# BURRIS/WAGNON ARCHITECTS, P.A.

## ADDENDUM NO. 4

Re: **GS# 102-276**  
**Residence Hall Improvements (Cain-Tatum-Fugler-Hammett & Brumby-Castle)**  
**Delta State University**  
**Cleveland, Mississippi**

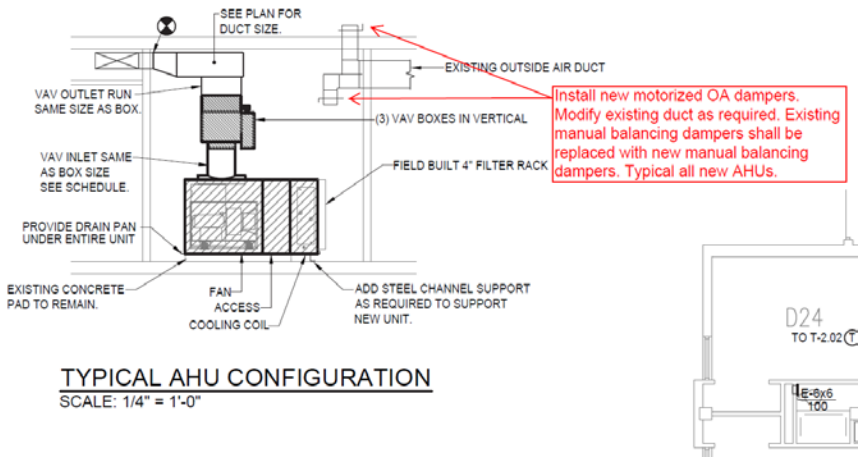
Item 3.	Reference:	Sheet M-201, Plan Note 2.
	Scope:	<p>Modify Plan Note 2 to the following:</p> <p>2. Mechanical Contractor shall blank off existing double door return air</p>

louver with sheet metal. Provide a 64x16" return air duct above door for return air path above ceiling. Install manual balancing damper in return air duct. Relocate existing piping, conduit, etc. as required to install new return air duct.

Carpet Plan -Second Floor (Cain-Tatum-Fugler-Hammett)

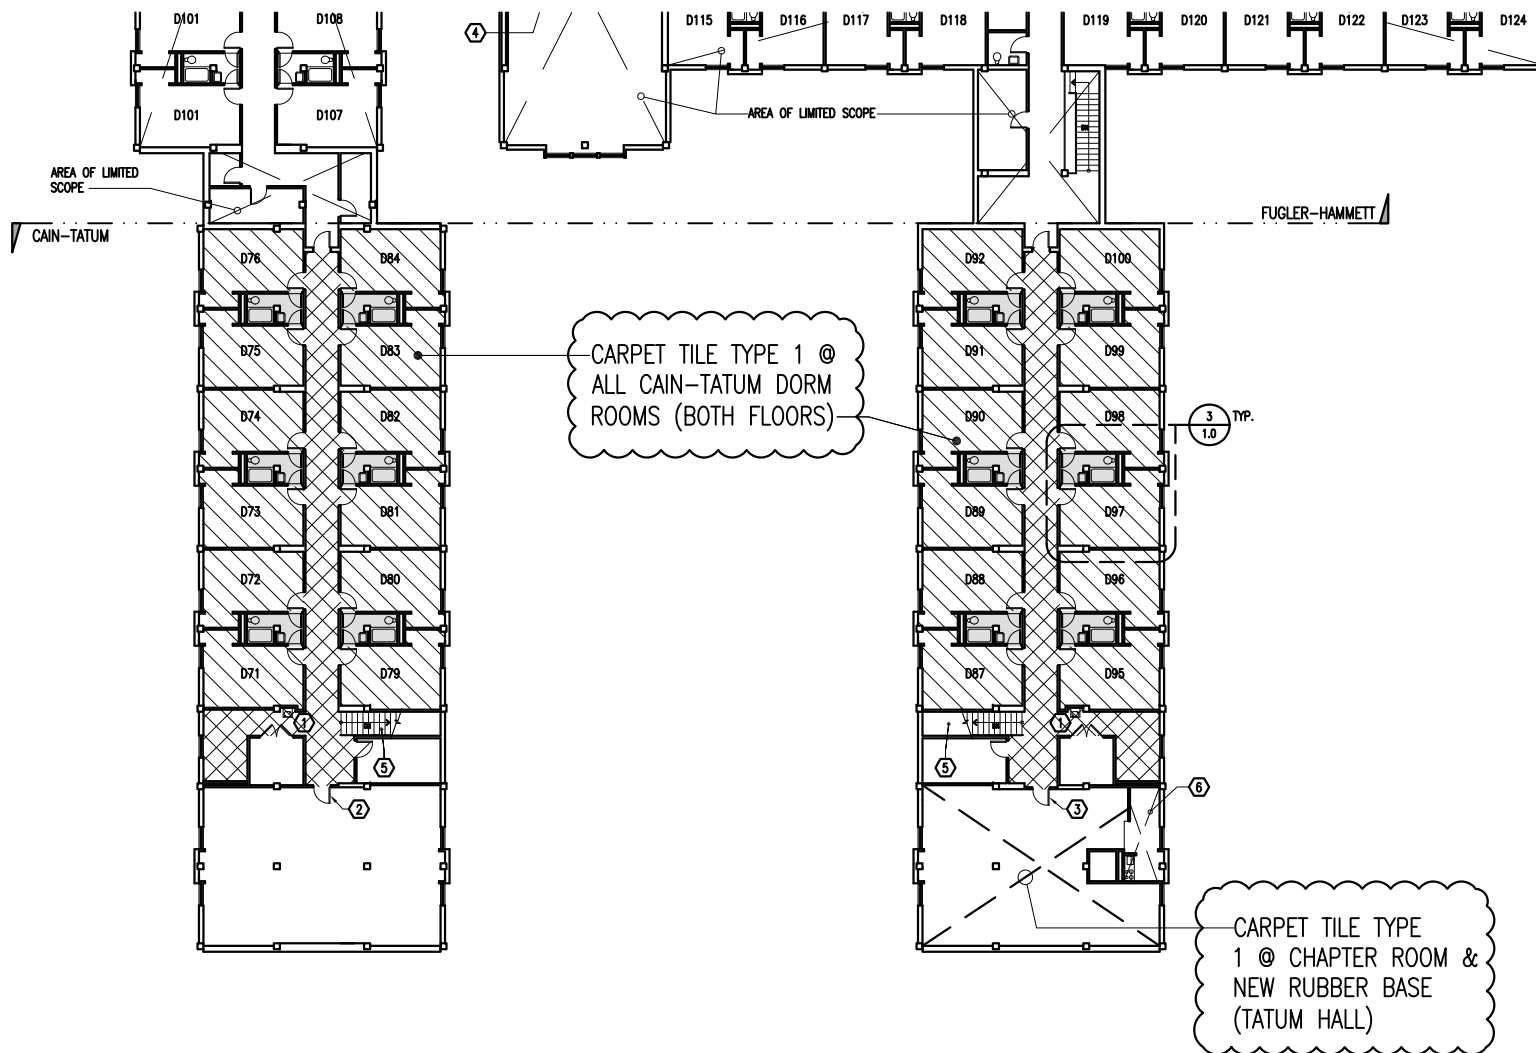
- Item No. 6:** Refer to Sheet 1.0, both floor plans (Cain-Tatum-Fugler-Hammett), and change as follows: Remove existing front lobby carpet and glue, to bare slab, and install new Carpet Tile (Type 2) at this area (existing wood base to remain -- paint); at second floor Tatum chapter room, remove existing carpet and glue to bare slab, and install new Carpet Tile (Type 1) with new rubber base at this room. See Exhibit "D" for both areas.
